Title - Sujet Roof Replacement	
Solicitation No. - N° de l'invitation F1700-150961/A	Amendment No. - N° modif. 001
Client Reference No. - N° de référence du client	Date 2016-01-18
GETS Reference No. - N° de référence de SEAG PW-\$PWY-005-7711	
File No. - N° de dossier PWY-5-38349 (005)	CCC No./N° CCC - FMS No./N° VME
Solicitation Closes - L'invitation prend fin at - à 02:00 PM on - le 2016-01-29	Time Zone Fuseau horaire Pacific Standard Time PST
F.O.B. - F.A.B. Plant-Usine: <input type="checkbox"/> Destination: <input checked="" type="checkbox"/> Other-Autre: <input type="checkbox"/>	
Address Enquiries to: - Adresser toutes questions à: Pillay, Sal (PWY)	Buyer Id - Id de l'acheteur pwy005
Telephone No. - N° de téléphone (604) 775-9386 ()	FAX No. - N° de FAX (604) 775-6633
Destination - of Goods, Services, and Construction: Destination - des biens, services et construction: DFO - West Vancouver Lab - West Vancouver, BC

Addendum 1

Project No	5437	Date	January 15, 2015
Project	Centre for Aquaculture and Environmental Research – ROOF REPLACEMENT 4160 Marine Drive West Vancouver, BC Department of Fisheries and Oceans – West Vancouver Laboratory

Structural Addendum S-1

1 ROOF PLAN

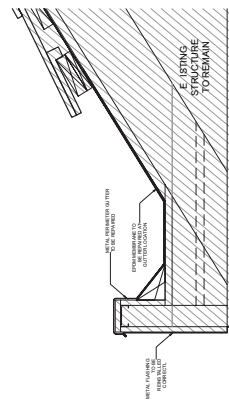
Add: Warehouse – Roof area 3.1 - Roof type 2 – specification note - limit the maximum weight of gravel ballast to 0.5 KPA (10 PSFR)

Add: Warehouse – Roof area 3.1 - Slope direction marks + slope lines
